Description of Work: Bath + closet addition

**RESIDENTIAL PLAN CORRECTION SHEET**

ADDENDUM TO PERMIT NO. 3635  
Owner Don Danuck  
Contractor Mike August Const.  
Location 1140 W. Riverview

WALL SECTION - BRICK VENEER

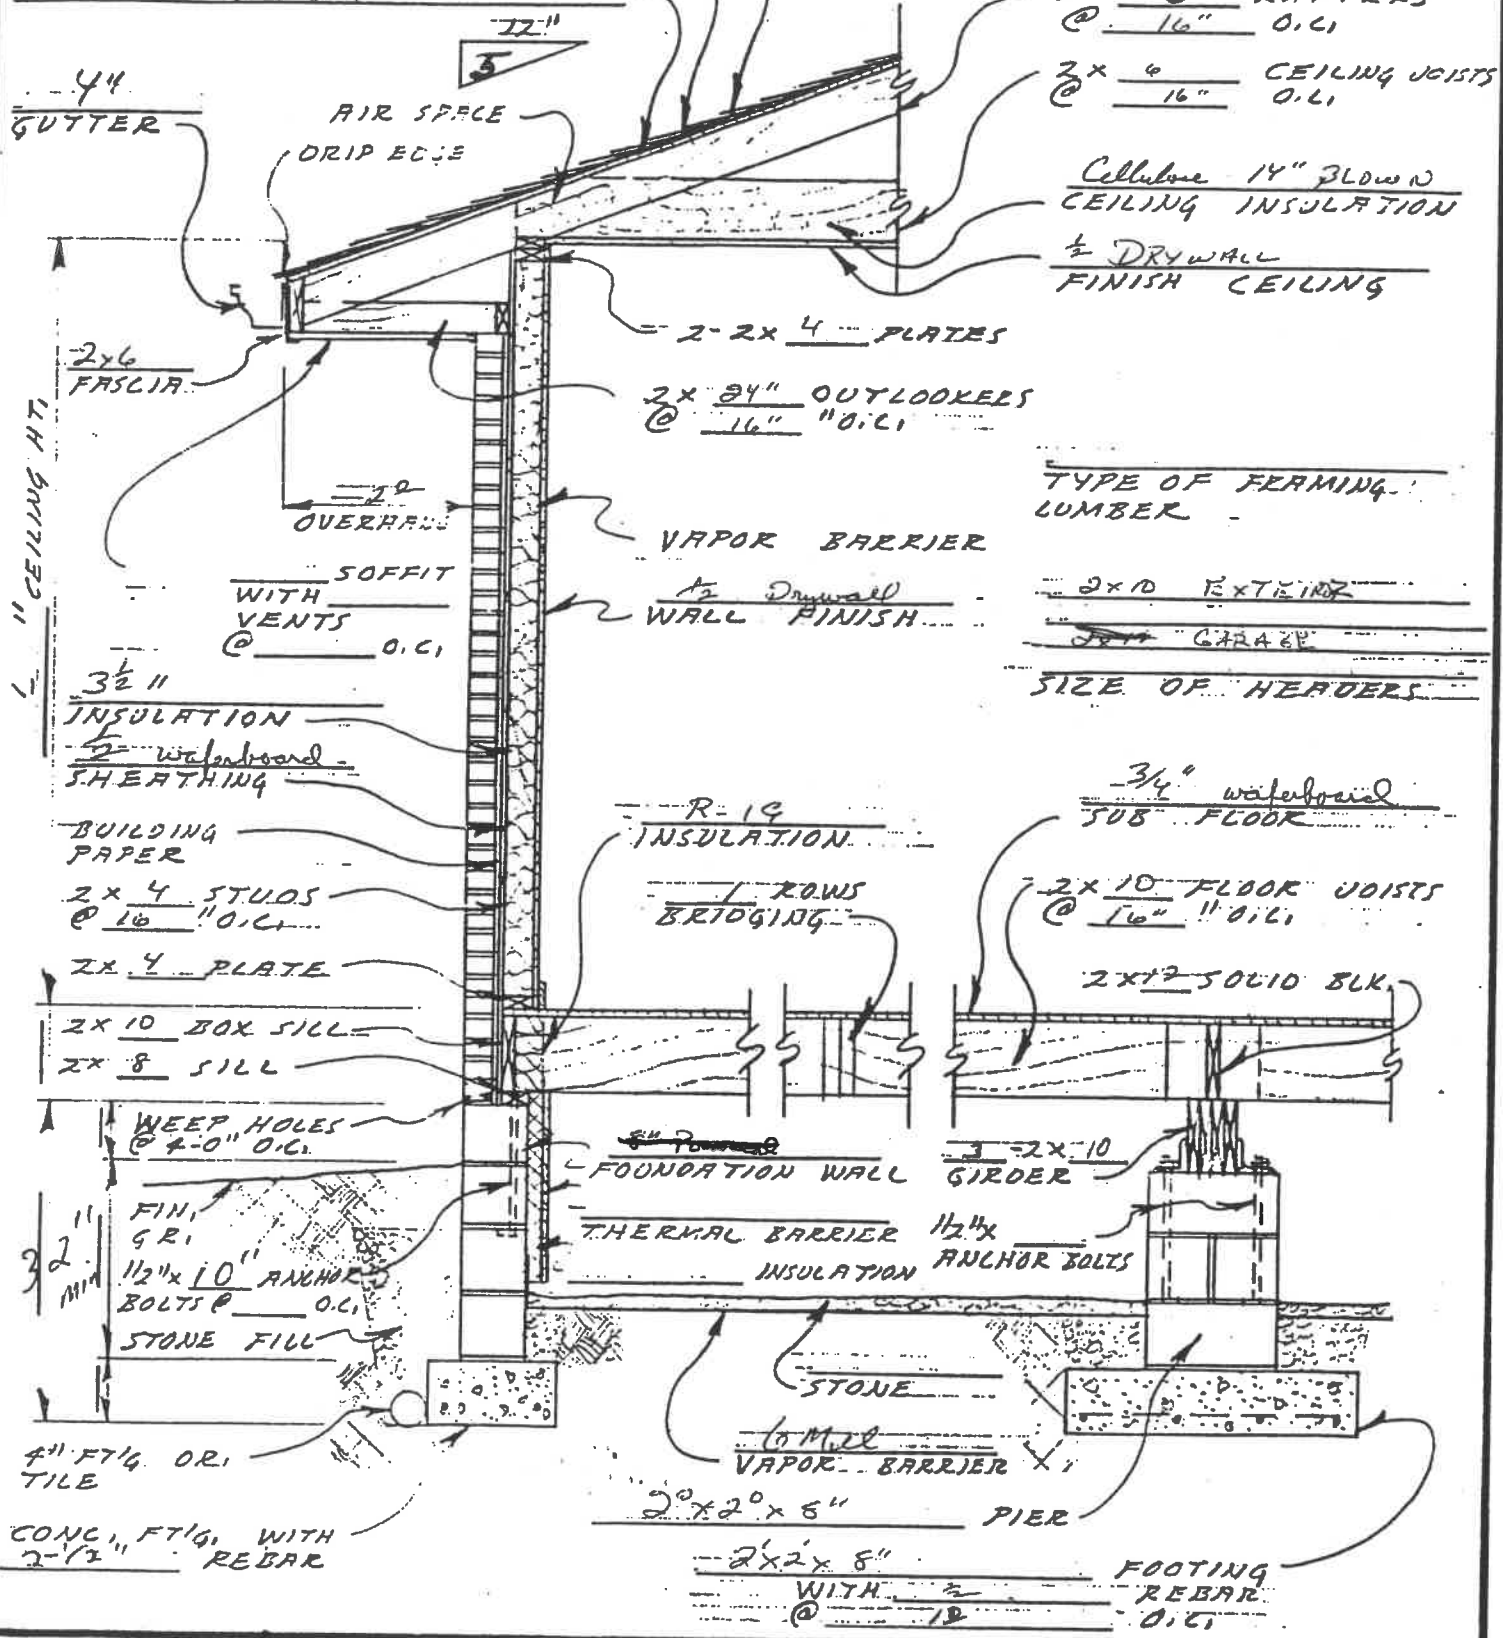
- Min. depth of foundation below finished grade is 36".
- Min. size of footer 8" x 12".
- Provide anchor bolts, 1/2" @ 6' o.c. 1' from each corner. Embedded 7" in concrete and 15" in masonry. you need 18" bolts
- Show size of basement columns.
